FERRET EXPLORATION COMPANY OF NEBRASKA, INC.

RE: Docket No. 40-8943
SUA No. 1534

RESPONSE TO COMMENTS
FROM
STATE OF NEBRASKA
DEPARTMENT OF ENVIRONMENTAL QUALITY
REVIEW LETTER DATED NOVEMBER 1, 1993

Ferret Exploration Company of Nebraska, Inc.	
FIGURE 1-1 CROW BUTTE PROJECT DAWES COUNTY, NEBRASKA SITE LOCATION MAP	
PROJECT: 0108-002	DATE: April, 1993
REV: 0	BY: HPD CHECKED: RLH
HARLAN, CASEY & ASSOCIATES, INC. <i>Consulting Engineers and Hydrogeologists</i>

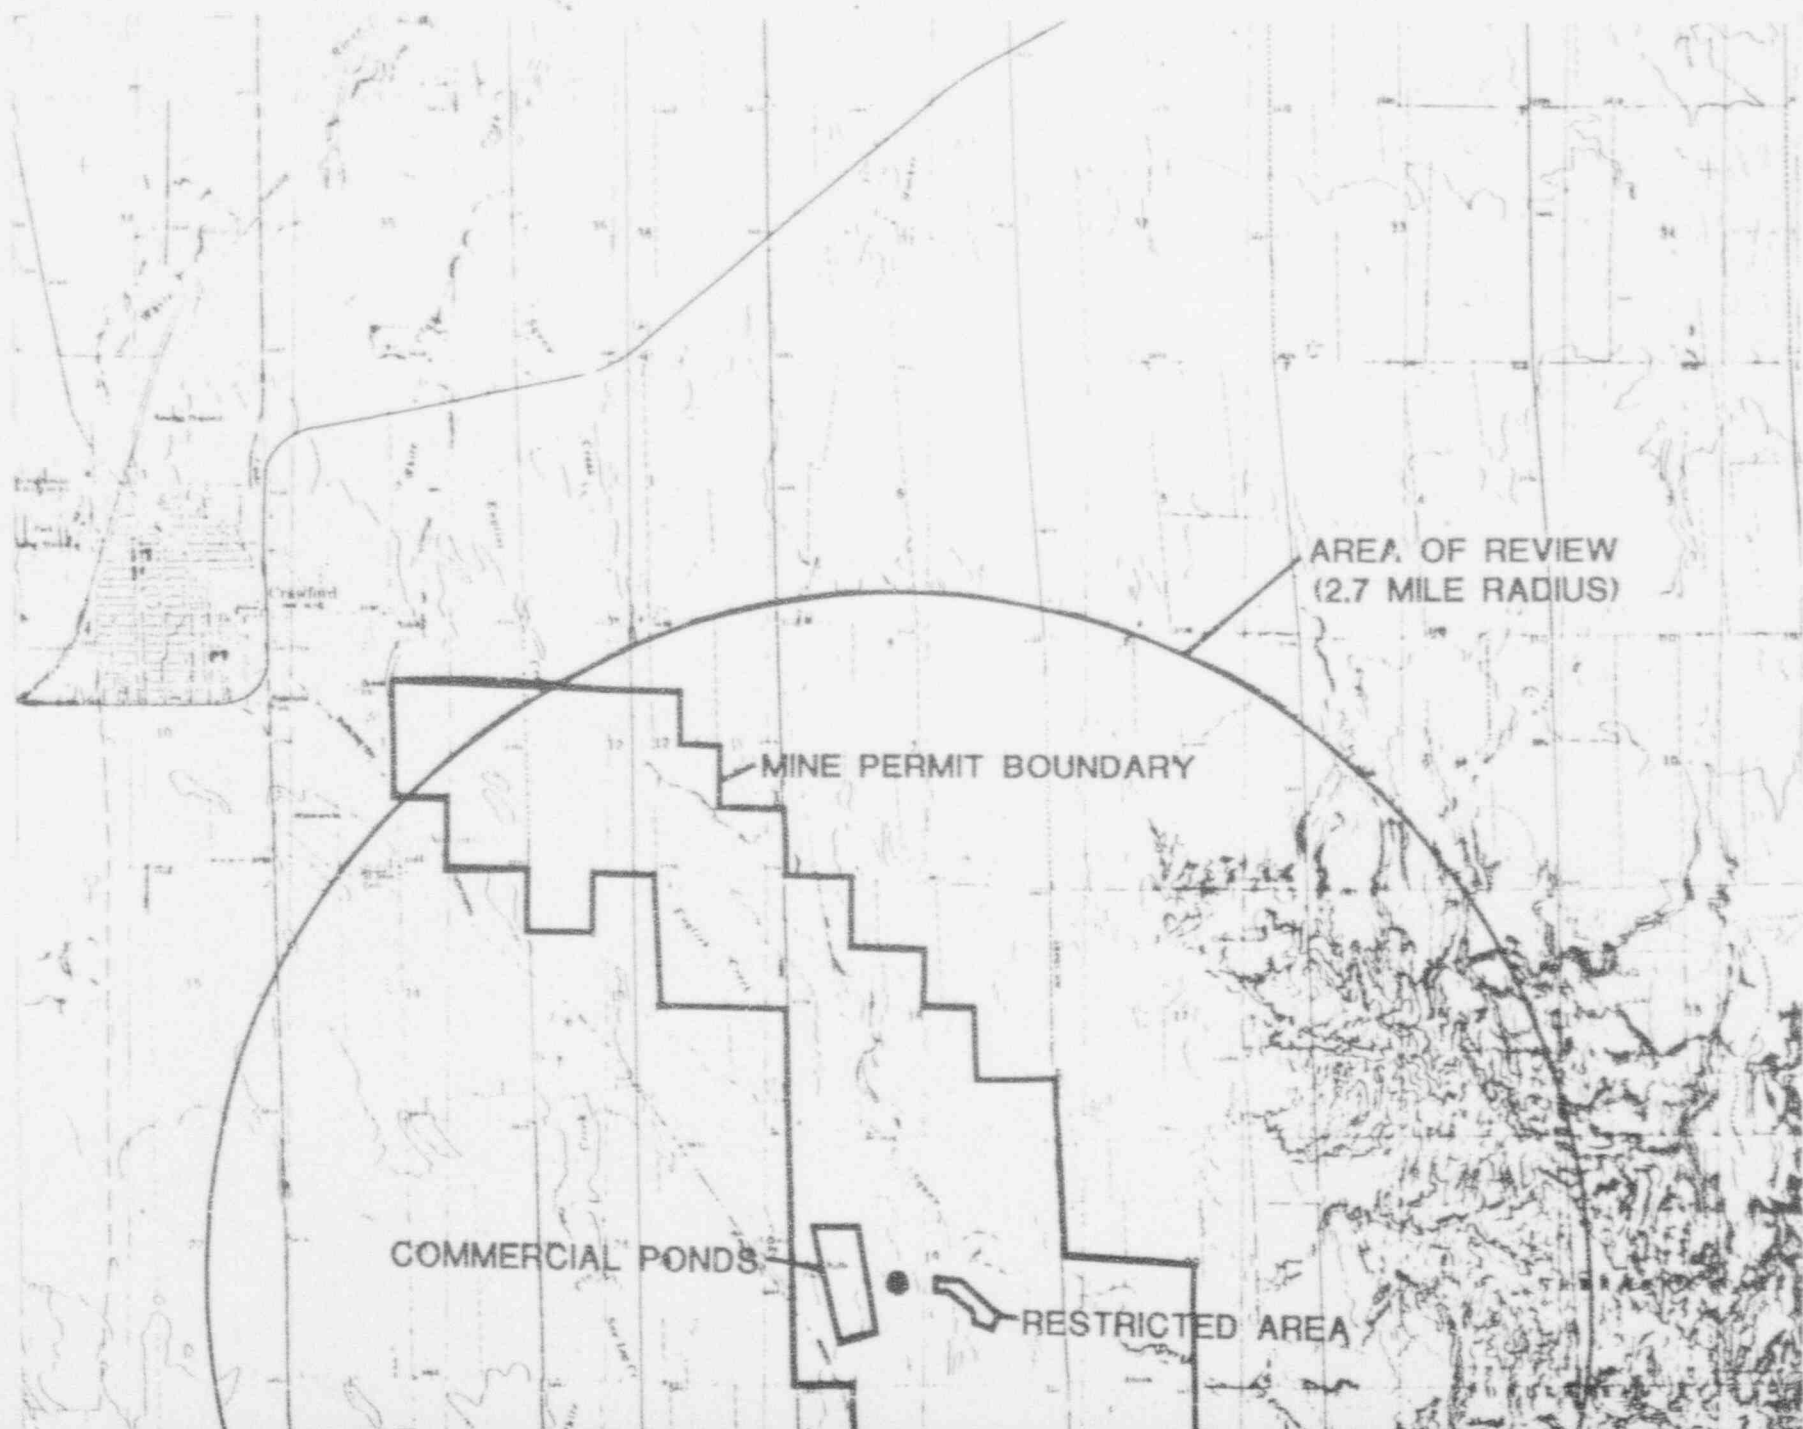
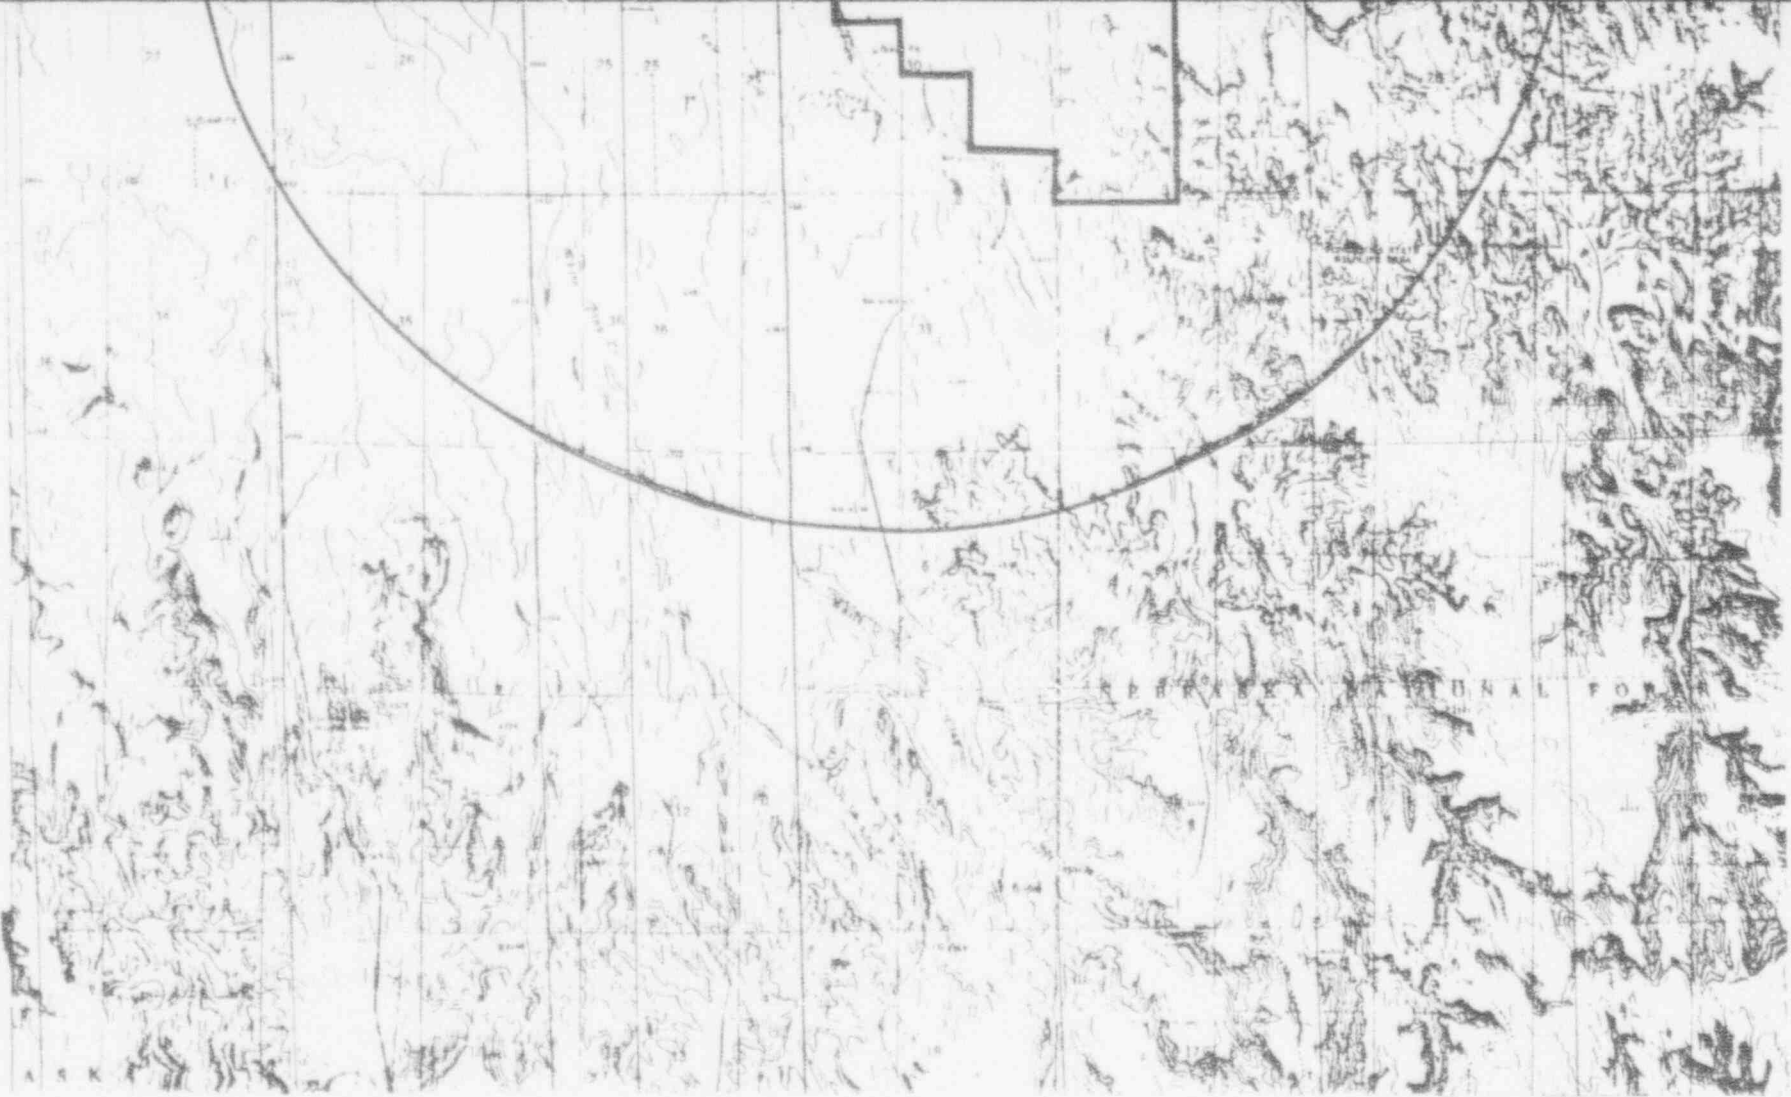
One small error on Figure 1-1 should be corrected. The "townships" listed on the right-hand side of the map have been located incorrectly. They should be adjusted so as not to create confusion with subsequent maps in the text.

The labeling on Figure 1-1 has been corrected. Please replace Figure 1-1 in the text with the enclosed corrected copy.

FIGURE 7-1
INJECTION WELL SCHEMATIC-
ALTERNATE CEMENT DESIGN

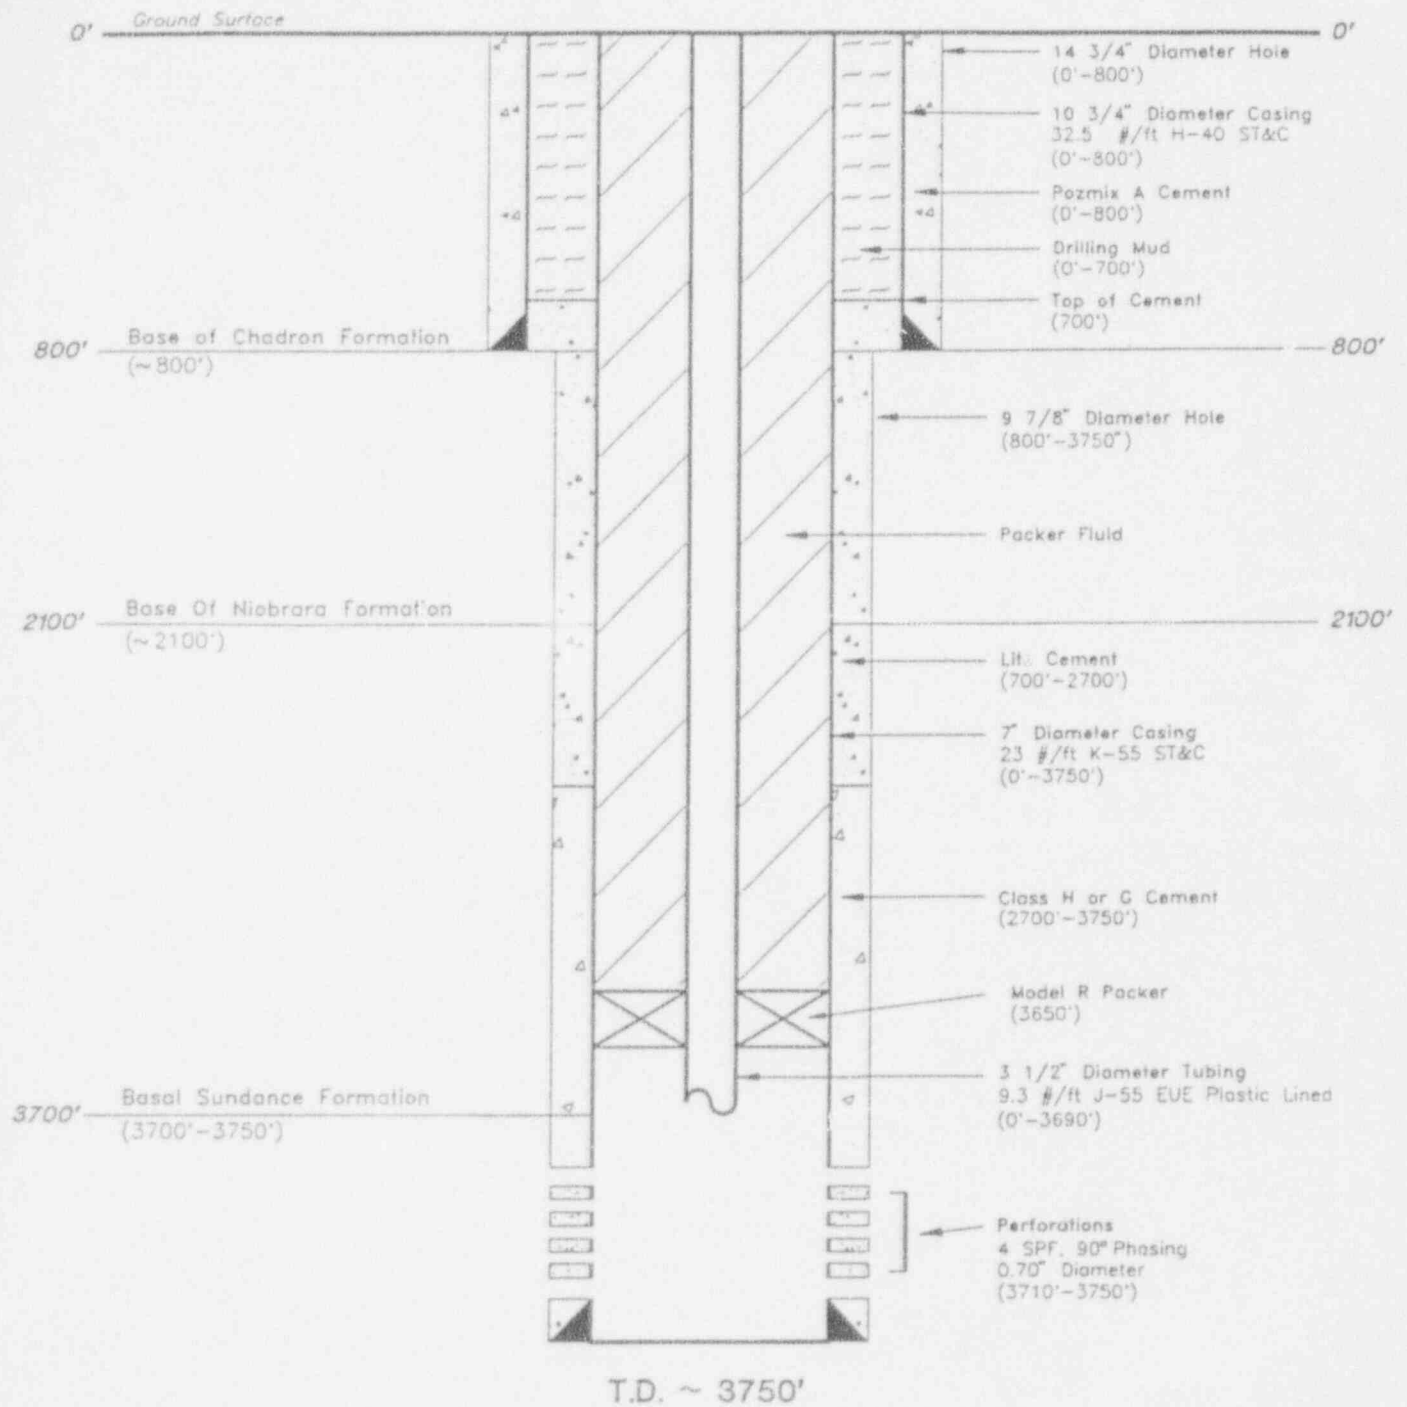
Figure 7-1 and supporting text indicate that the proposed injection well will not be cemented from a depth of approximately 800 feet to 2100 feet (Base of Chadron Formation to Base of Niobrara Formation). The reasons listed for not running cement in this interval are listed on page 61, and include: "(1) the pressure induced by 3750 feet of cement would exceed the formation fracture pressure, (2) the cement will be high enough to isolate all of the lower sand intervals (i.e., from the "D" Sand through the basal Sundance), and (3) shallow freshwater zones (i.e., the Brule and Chadron Formations) will already be isolated by the 10½" surface casing and associated cement". Department staff have reviewed this section of the application, and determined that the proposed cementation completion may need to be altered. For example, oil and gas wells are commonly completed by running cement through the entire long string interval from the base of the surface casing to total depth. The Department is unaware of completion problems associated with this practice and the potential to exceed formation fracture pressure. Another factor that may complicate the proposed construction is the water quality within the Dakota Formation. Since the water quality of the Dakota Formation has not yet been established at the site, the proposed injection well may need to be cemented through the Dakota interval in order to satisfy requirements in Nebraska Title 122, Chapter 15, part 002.01B. In consideration of the life expectancy of the proposed injection well, it would be prudent to seal the annulus from total depth to surface so as to minimize any potential for vertical migration of fluids.

- Lead Cement: 250 Sacks Class G or H "lite" mixed at 11.4 #/gallon with a yield of 2.95 ft³/sx. This amount of cement would extend from the ground surface to approximately 2700 feet.
- Tail Cement: 200 Sacks 50/50 Pozmix mixed at 14.3 #/gallon with a yield of 1.27 ft³/sx. This amount of cement would extend from 2700 feet to the bottom of the hole (3750 feet).

In summary, FEN prefers the cementing program presented in the original text. However, to address concerns expressed by the Department, the alternate cement design discussed above has been presented. This design will fill the annulus from total depth to 100 feet inside the surface casing shoe, as shown on a the attached revision of Figure 7-1 (wellbore schematic).
